SOUTH SAN FRANCISCO FERRY TERMINAL PIER STRUCTURES

ADDENDUM NO. 2

December 9, 2009

Pre-Proposal Meeting attendees and notes
Q&As
Modification to Pier Doors
Modification of Liquidated Damages Paragraph
Changes the date and time that technical proposals are due
Remove redundant specification section on coatings
Remove specification section on the steel gangway

5 CONCRETE STEM WALL @ METAL PANELS
SCALE: 3" = 1'-0"

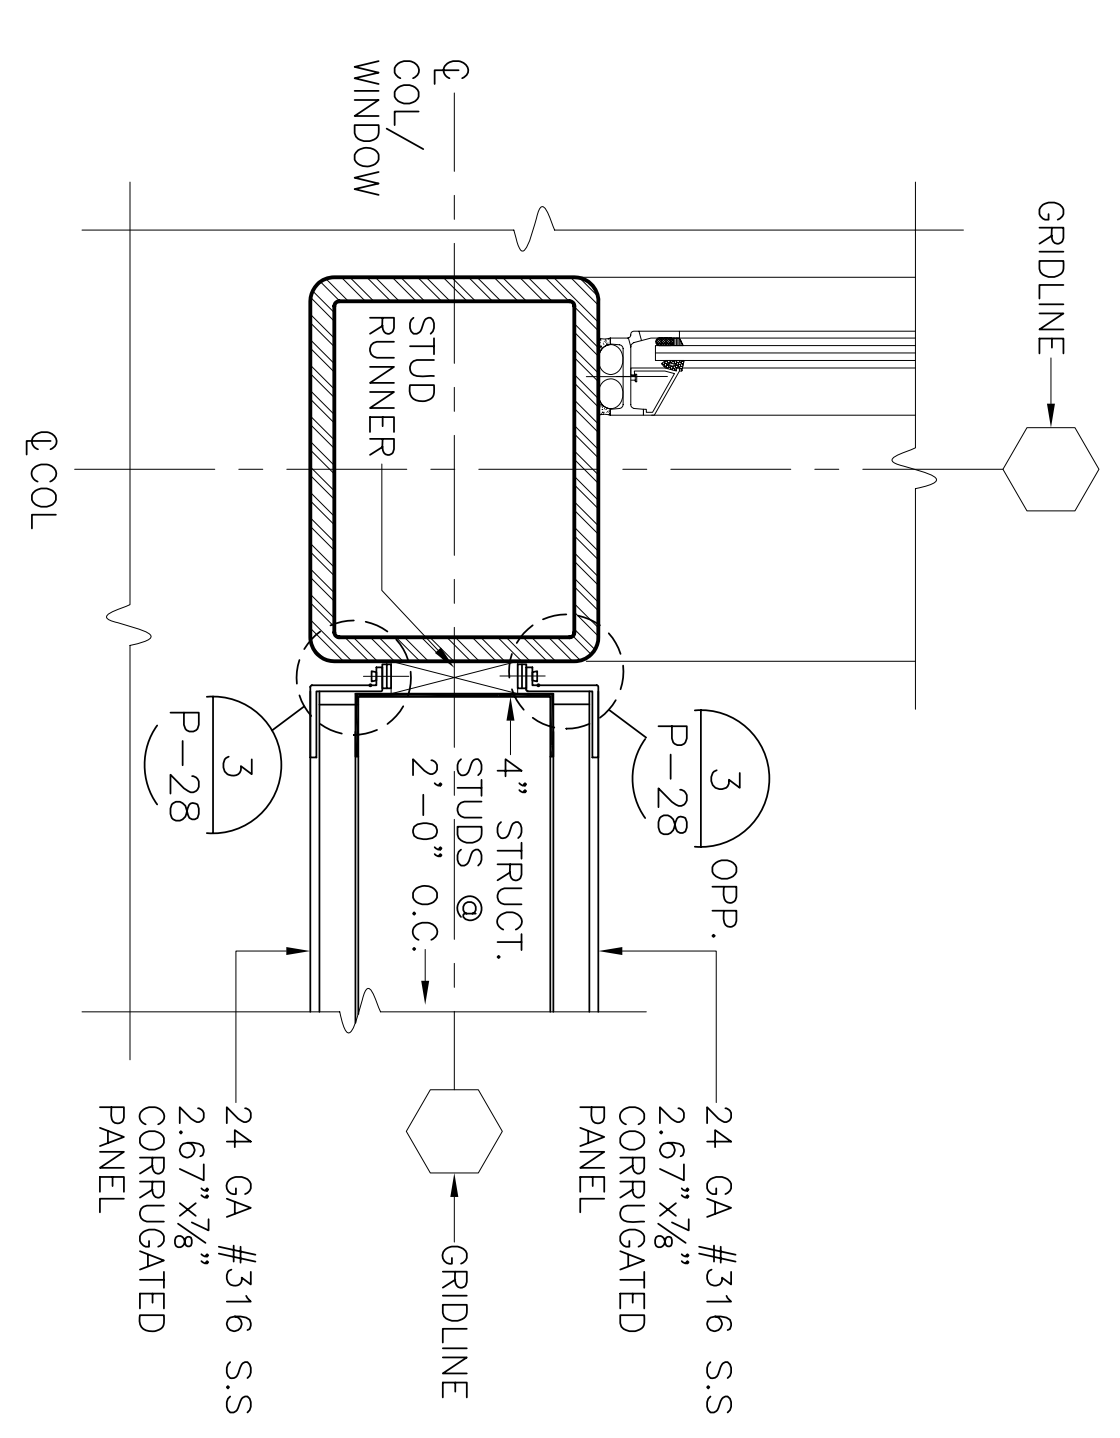
- A81: Yes, it is acceptable
- Q82: Package 2, drawing P-25, Details 1, 4, 5, and 8: The doors are currently drawing with no immediate vertical framing, using instead the steel vertical posts. It is recommended that a door frame from the manufacturer be introduced in order to facilitate typical fabrications such as door hinges, electrical wiring, and to address any clearance issues against the structural steel framing. This can be made from the same stainless steel material as the door leafs. Will this be acceptable?

- A82: Yes, the approach of using a stainless steel door frame would be acceptable subject to review of the specific proposed details.
- Q83: Package 2, drawing P-21, Detail A and 3: There is a 1/8" bent plate flashing shown on the 8" x 4" HSS beam. Is there a preferred attachment method by the owner (welded, mechanically fastened)?

DRAWING NO.
P-29

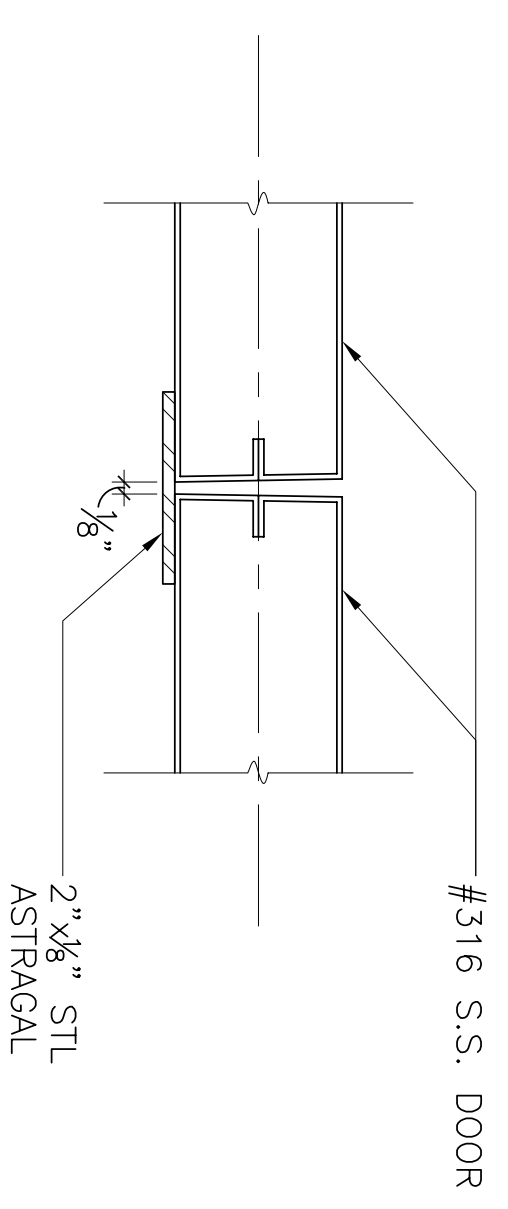
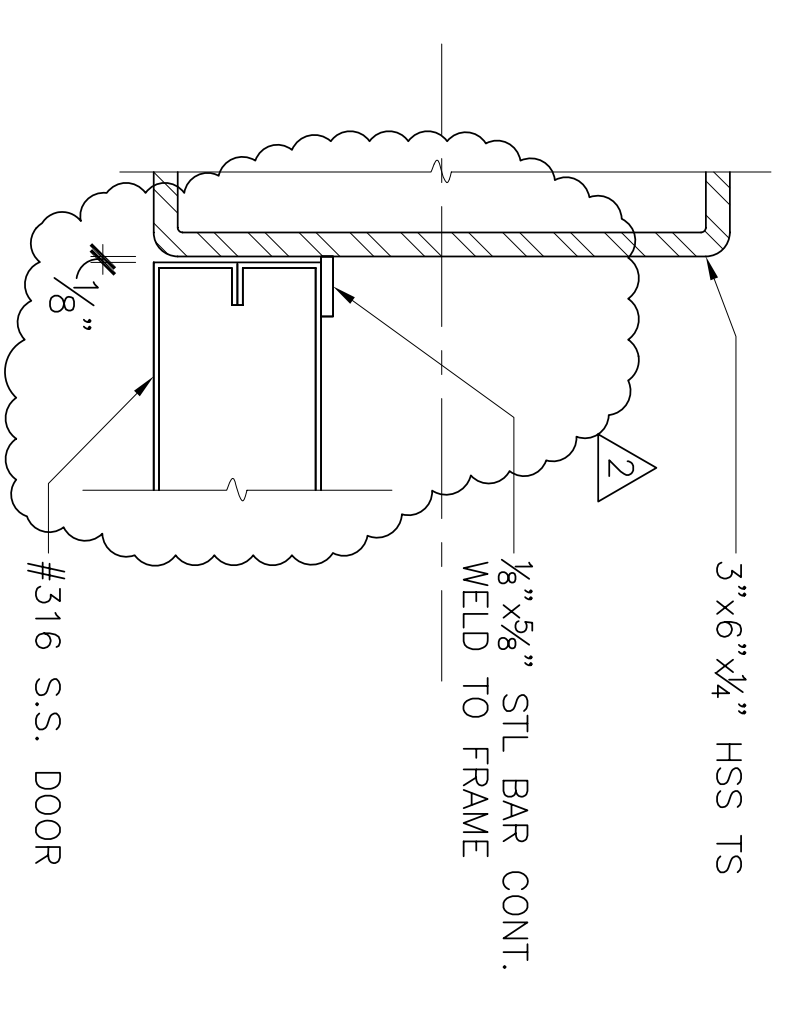
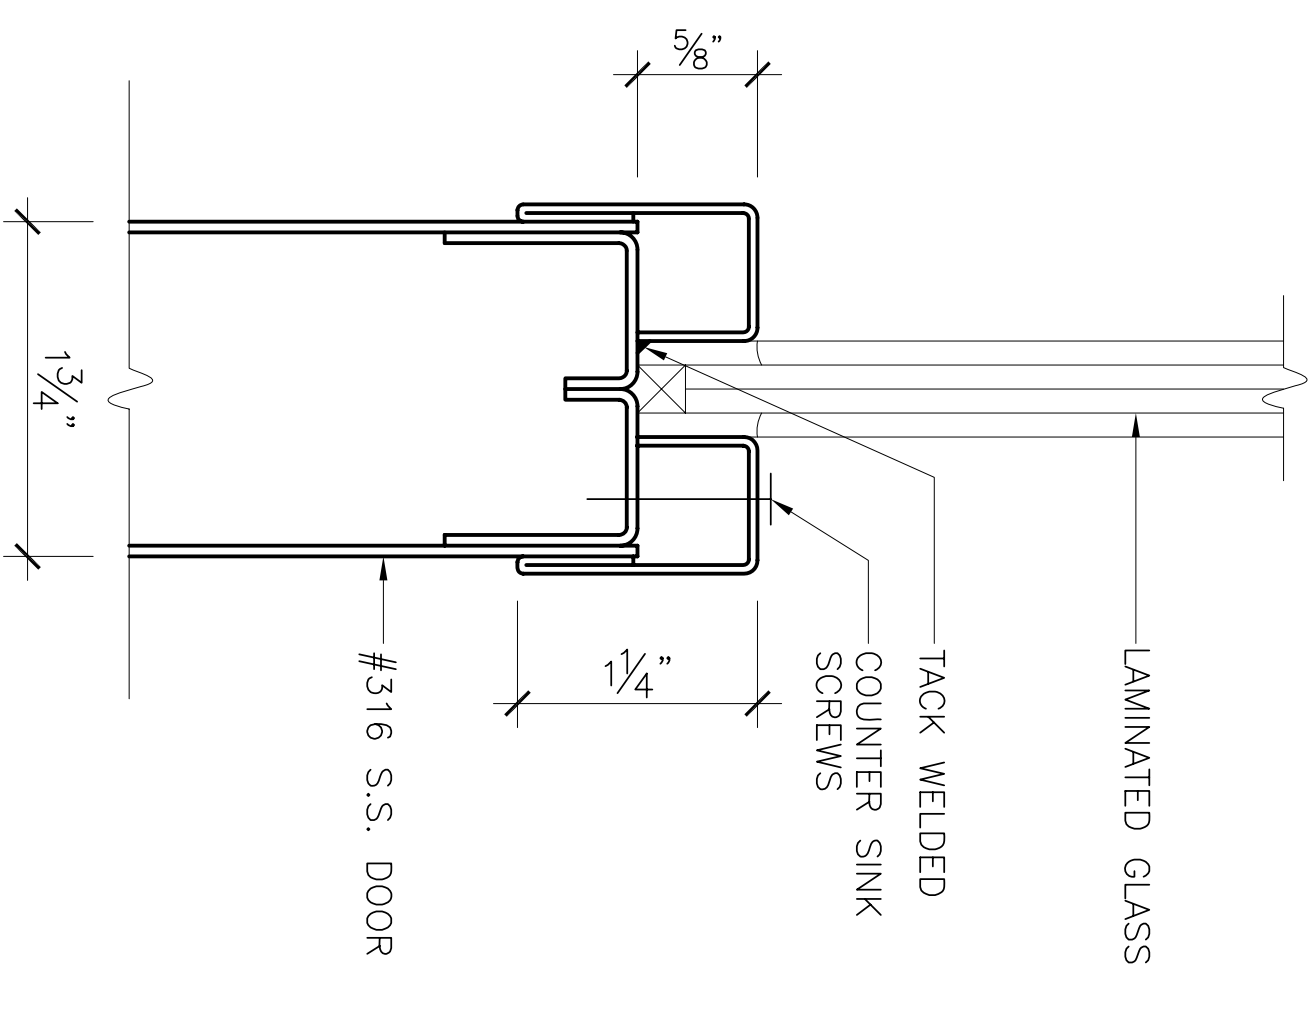
- Q97: Center Hung Doors cannot Swing 180 Degrees as shown, as they will be stopped by the jamb. We have been able to Swing Doors 180 Degrees by using Horton's 4100 Power Swing Operator on the pull side of the Doors and using a Custom Arm arrangement. Please clarify.

- A97: Doors have been relocated to be flush with HSS TS to allow 180° swing. See change specification and drawing changes attached to Addendum 2 for the Package 2 RFP.
